**SOIL REMEDIATION REPORT
O'HENRY LAUNDRY, TUTU, ST. THOMAS
U.S. VIRGIN ISLANDS**

IT Project No. 409830

Revision No. 1

August 1995

FIGURE 2-4

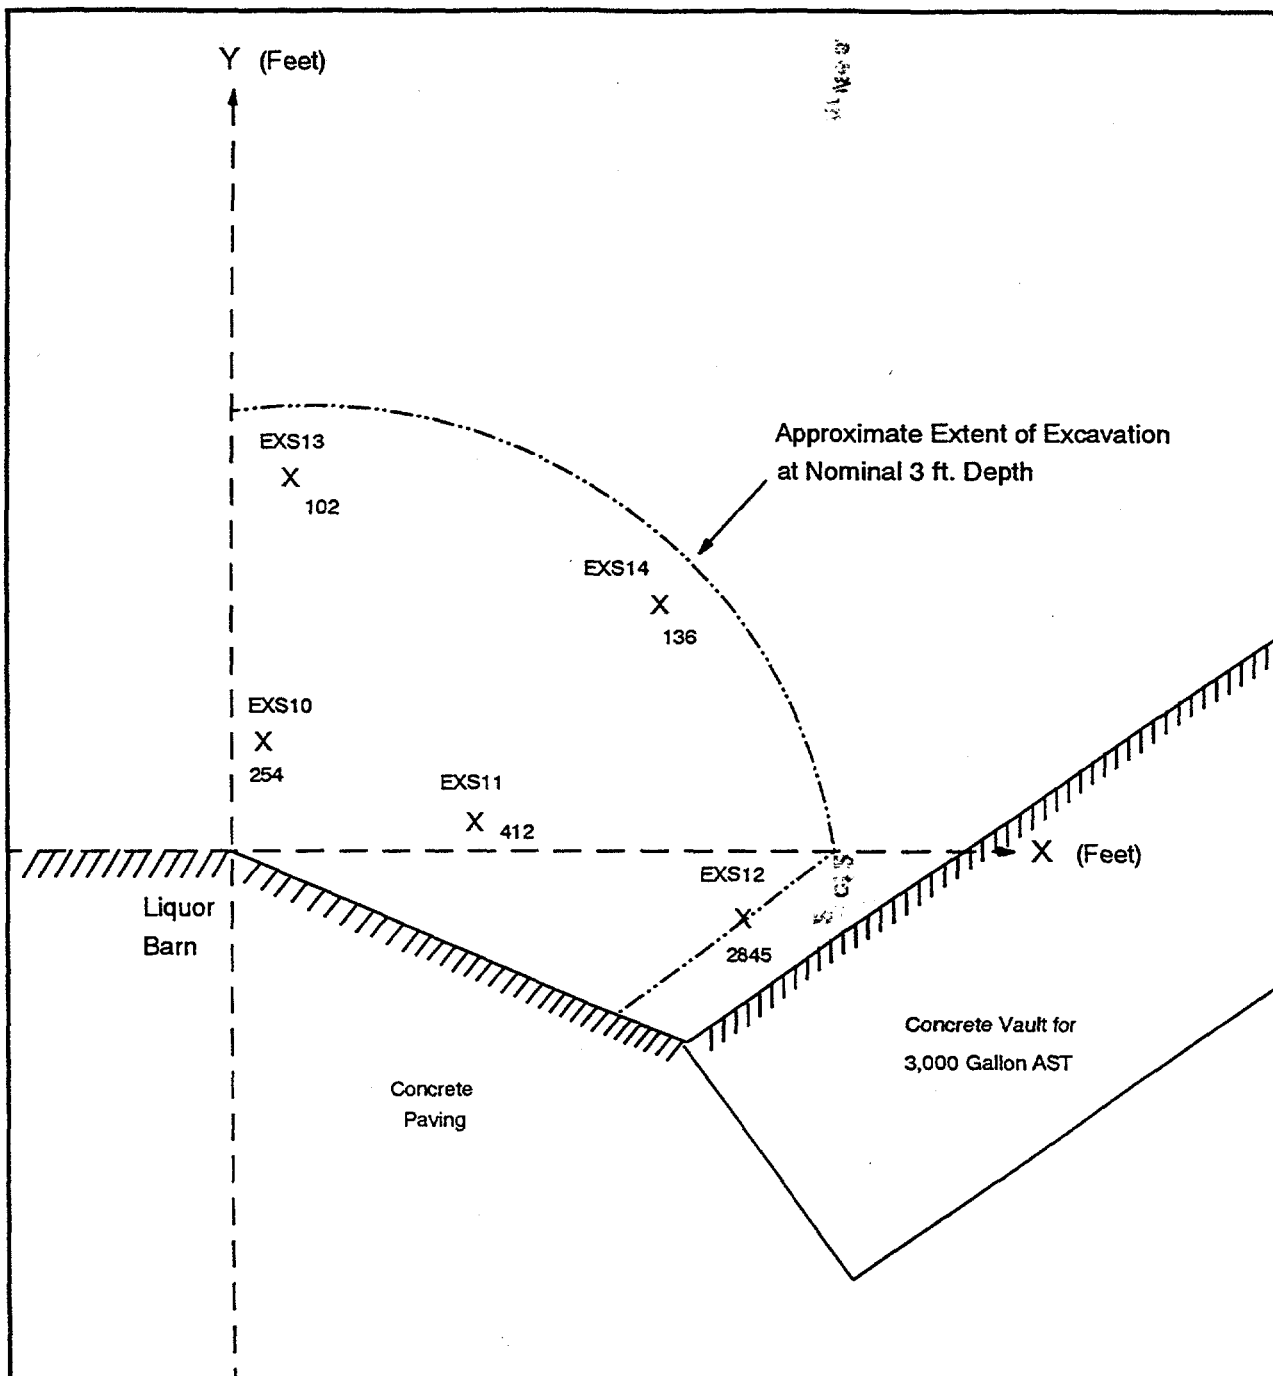
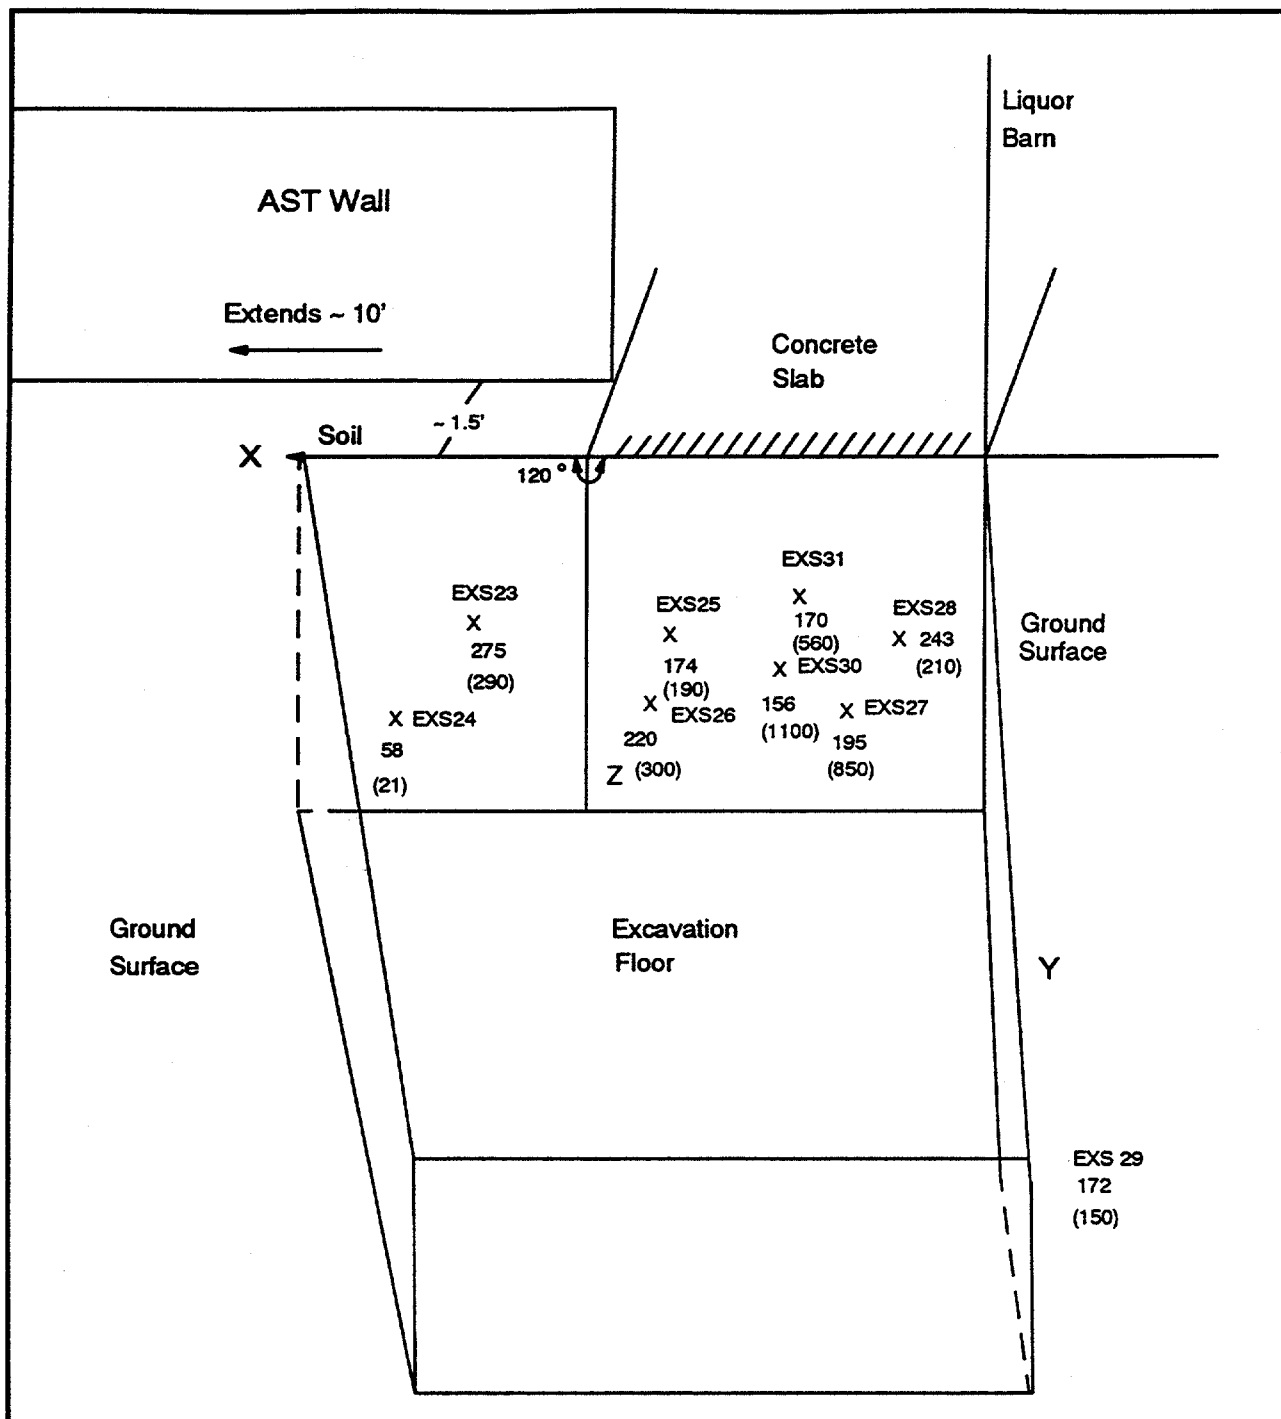
Comment 14: Section 5.0, page 5-2. The text states that PCE concentrations were below detectable levels beneath 10 ft in boring ITSB-01. The report should indicate, however, that this boring may not be indicative of concentrations in surrounding soils. Based on sampling results shown in Figures 2-4 and 2-7, the higher PCE concentrations exist in nearby soils.

Response: Based on an evaluation of the spatial PCE concentrations from field GC and laboratory confirmation sampling shown in Figures 2-3 through 2-7 of the report, the depth profile for PCE concentrations in boring ITSB-01 appears representative of the depth profile of PCE concentration in soil in the excavation area. PCE which may have entered soil and migrated from the unpaved area back under the concrete will have the following characteristics:

Given the above characteristics and visual observations which indicate no residual free phase in soil and no vertical pathway for preferred contaminant migration (soils are uniform) the contaminant profile in boring ITSB-01 may not be indicative of concentrations in soils beneath the paved area in terms of actual concentrations; however, it likely accurately reflects the "general profile" where the maximum concentration of PCE in soil is between 5 and 10 feet below grade and there is non-detect below 10 feet. This will be added to the text.

FIGURE 1

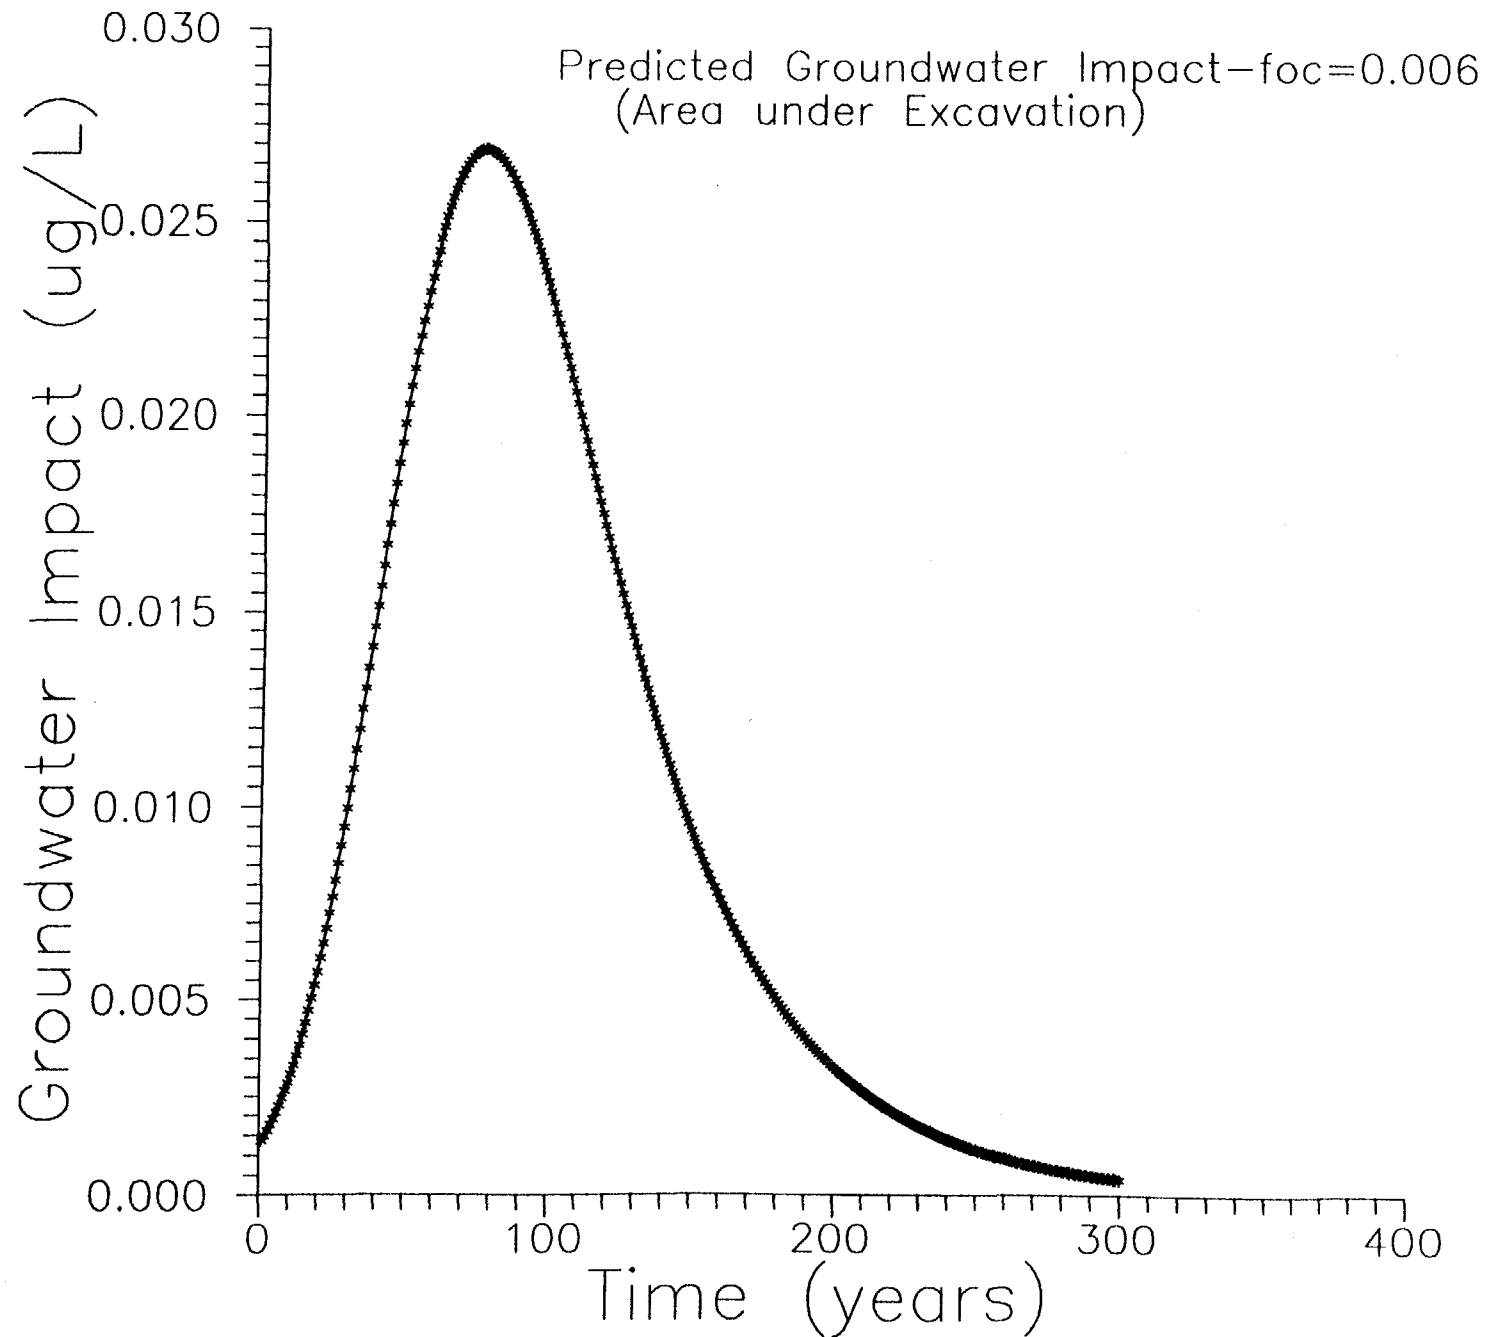
Comment 1: The limits of the excavation were determined from field gas chromatograph results and using a provisional soil cleanup level of 200 ug/kg, based on preliminary vadose zone leaching modeling. The final EPA cleanup goals for the O'Henry property, based on revisions to the model, are 375 ug/kg PCE in the 0-1.6 feet depth interval, and 31 ug/kg PCE at depths greater than 1.6 ft, which will result in levels of PCE in groundwater below the MCL of 5 ug/l. These cleanup goals are developed from unsaturated zone calculations that take into account infiltration of precipitation, PCE adsorption-desorption from site soils, anaerobic biodegradation of PCE and mixing of contaminated leachate with groundwater in the underlying aquifer. Based on the final EPA calculations, additional soils remediation is needed to address potential sources of groundwater contamination.

Response: Cleanup standards calculated by the EPA assume soil contamination occurs at the soil cleanup standard concentration for the entire soil column. Site modeling performed by the EPA and reported in specific comment No. 15 does not take into account all site specific data available. Further, IT cannot verify the results of EPA modeling presented for the O'Henry site because site specific input parameters, input/output files, and spreadsheet calculations have not been presented. However, using the leachate to groundwater dilution factor of 0.04 assumed for the O'Henry site by the EPA (CDM, 1995), and back-calculating from the groundwater MCL for PCE of 5 ppb, the equivalent concentration of PCE in leachate entering groundwater would be 125 ppb. This value is higher than the soil cleanup standard of 31 ppb presented by the EPA which would suggest that the soil cleanup standard must be greater than 125 ppb.

The incremental increase in PCE concentrations in groundwater for the O'Henry site using the two PCE concentration soil profiles are shown in Figures 1 and 2 respectively. Table 2 summarizes the highest groundwater PCE concentrations and the time at which the peak impact occurs beneath the site. Figures 1 and 2 show that with the current PCE soil concentration profiles, groundwater beneath the O'Henry site will not be impacted above EPA action limits. The site specific modeling will be incorporated into a new chapter titled, "Evaluation of Impact to Groundwater of Soils Left in Place."
